ADDENDUM

Project: Camp Ben Lomond Eating Shelters

Addendum No.: 01

Date: October 17, 2025

C121

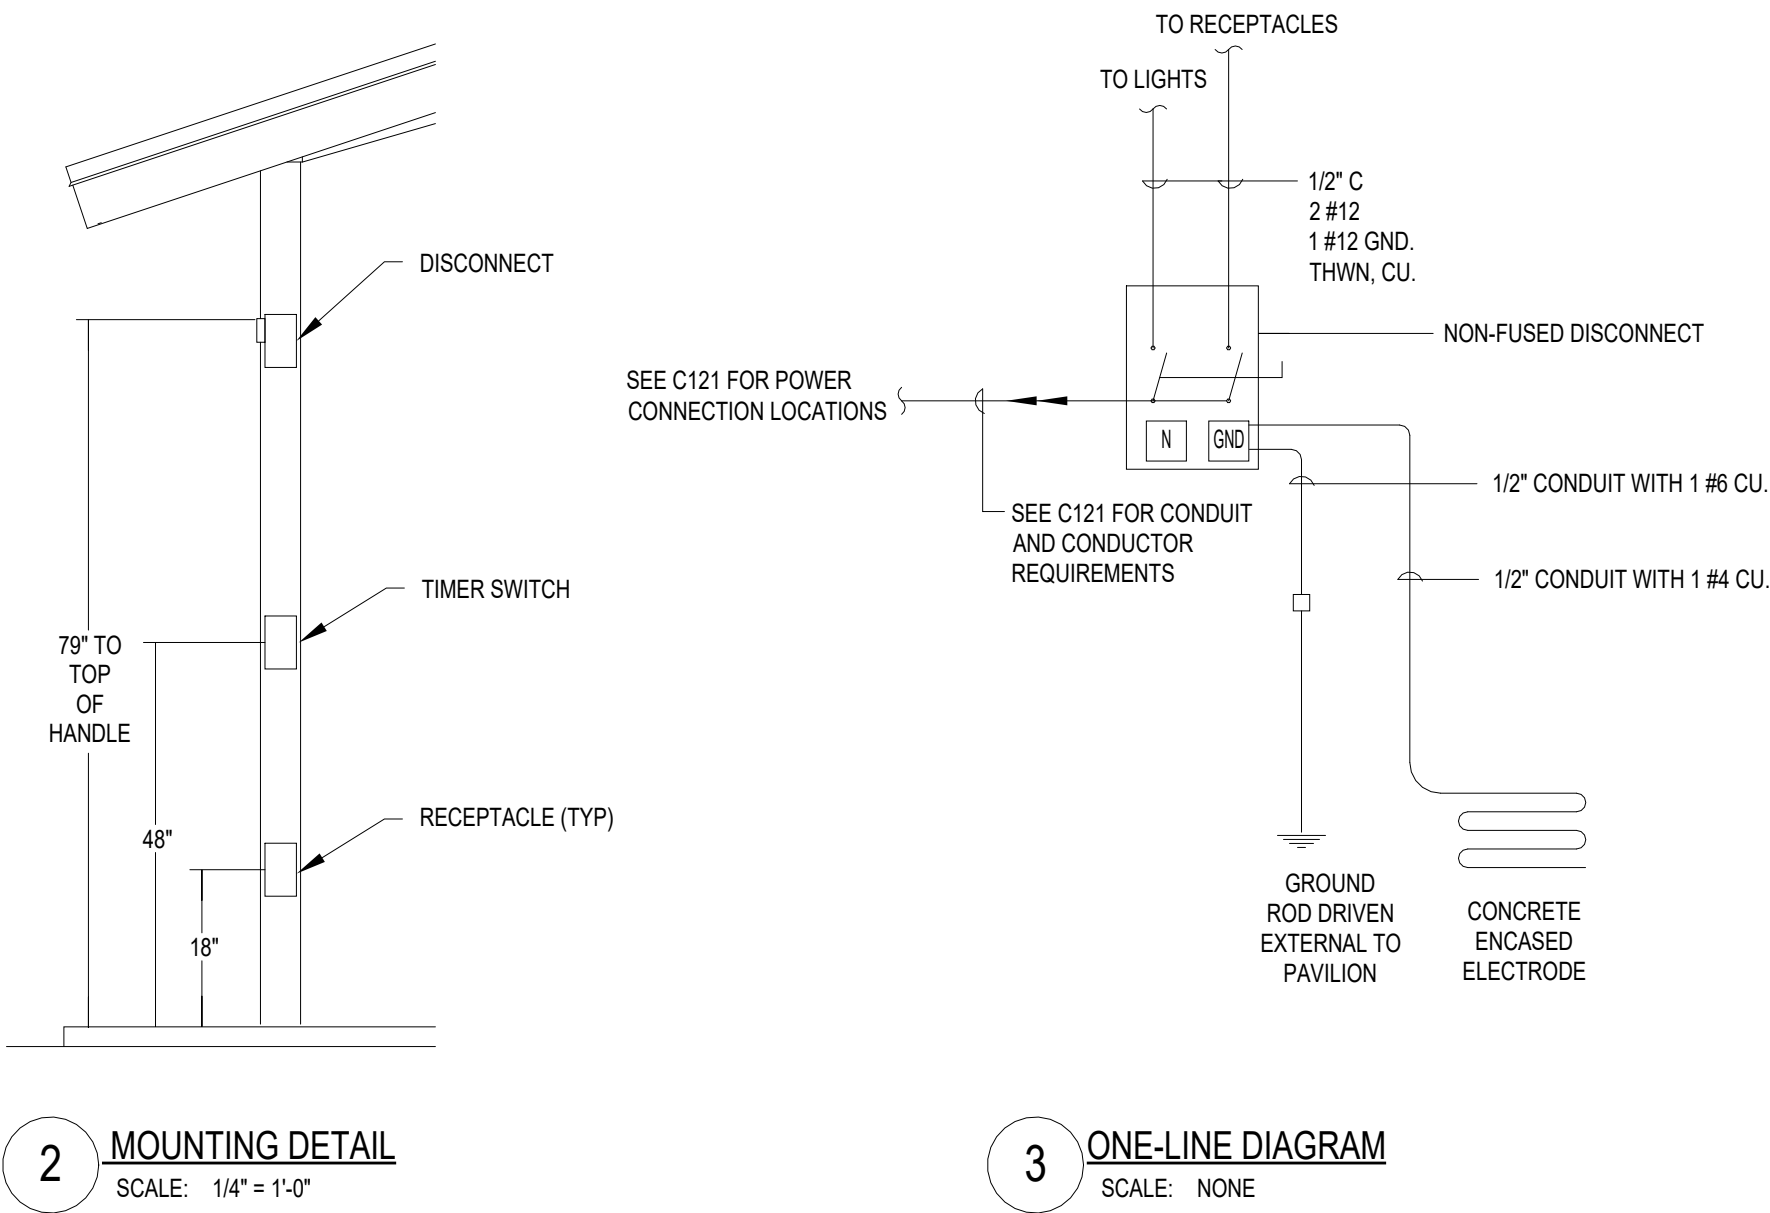
The contractor shall include all costs associated with all electrical work shown on sheets C121 and C122 as Bid Alternate #1. These costs SHALL NOT be included in the base bid. The contractor shall upload a PDF on their letterhead with these costs.

Provide all required conduit, branch circuits, four (4) light fixtures (F1), one (1) receptacle with weatherproof cover, lockable non-fused, NEMA 3R, 30A, 2 pole disconnect and 0-60 minute timer switch with weatherproof cover for lighting controls for pavilion. See C122 for fixture requirements.

Provide all required conduit, branch circuits, four (4) light fixtures (F1), one (1) receptacle with weatherproof cover, lockable non-fused, NEMA 3R, 30A, 2 pole disconnect and 0-60 minute timer switch with weatherproof cover for lighting controls for pavilion. See C122 for fixture requirements.

Provide all required conduit, branch circuits, four (4) light fixtures (F1), one (1) receptacle with weatherproof cover, lockable non-fused, NEMA 3R, 30A, 2 pole disconnect and 0-60 minute timer switch with weatherproof cover for lighting controls for pavilion. See C122 for fixture requirements.

Provide all required conduit, branch circuits, four (4) light fixtures (F1), one (1) receptacle with weatherproof cover, lockable non-fused, NEMA 3R, 30A, 2 pole disconnect and 0-60 minute timer switch with weatherproof cover for lighting controls for pavilion. See C122 for fixture requirements.
